H11138

DESCRIPTIVE REPORT

Descriptive Report to Accompany Hydrographic Survey H11138

Project OPR-P182-RA
Southwest Alaska Peninsula, Alaska
Scale 1:20,000
June - July 2002
NOAA Ship RAINIER
Chief of Party: Captain James C. Gardner, NOAA

Figure 2. H11138 Junction Surveys

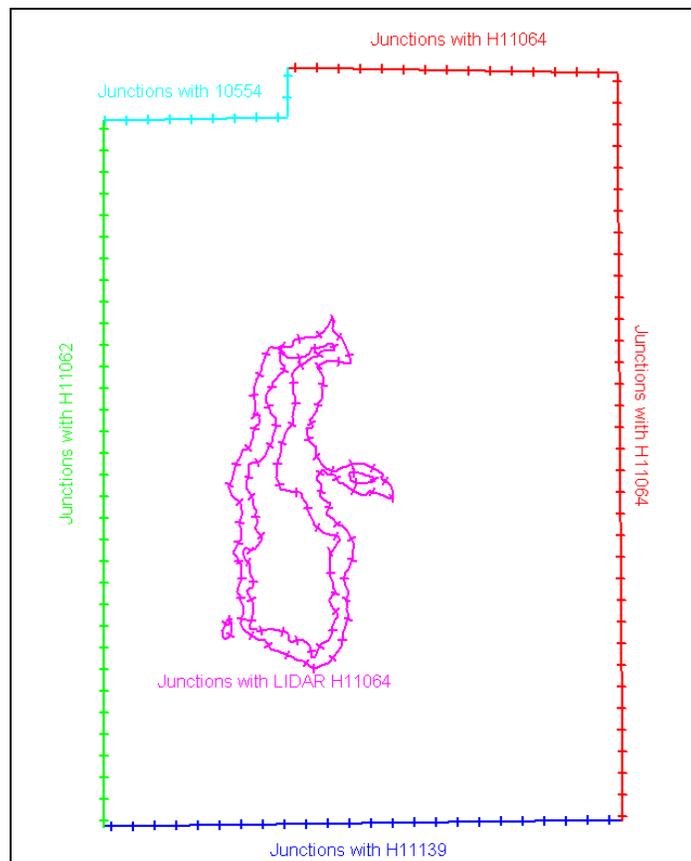
Survey H11062 junctions well with this survey, a cursory comparison indicates that 99.6% of junction has differences less than 2.0 fathoms with a maximum difference of 3.6 fathoms.¹⁰

Survey H11064 (LIDAR) junctions fairly well with this survey. A cursory comparison indicates that approximately 80% of the junction has differences of less than 2.0 fathoms. In some instances, there were areas with larger differences, up to 5.0 fathoms. The hydrographer believes this is due to the steep and irregular bathymetry near shore.¹¹

Survey H11069 junctions well with this survey, a cursory comparison indicates that 98.9% of the junction has differences less than 2.0 fathoms with a maximum difference of 3.4 fathoms.¹²

Survey H11139 junctions well with this survey.¹³

¹⁰ Concur.

¹¹ Concur with clarification. LIDAR soundings from H11064 were placed on Level 19 of the smooth sheet to complete coverage of near-shore areas. Since LIDAR may be affected by turbidity, it is currently assumed that multibeam soundings become increasingly more accurate than LIDAR with increasing depth. Where there were differences between multibeam and LIDAR soundings in the survey, generally the multibeam soundings are shoaler.

¹² Concur.

¹³ Concur.

¹⁴ The junction with surveys H11062, H10554, H11069, and H11139 are complete; soundings and depth curves are in good agreement within the common area. A “Joins” note has been shown on the smooth sheet where applicable.
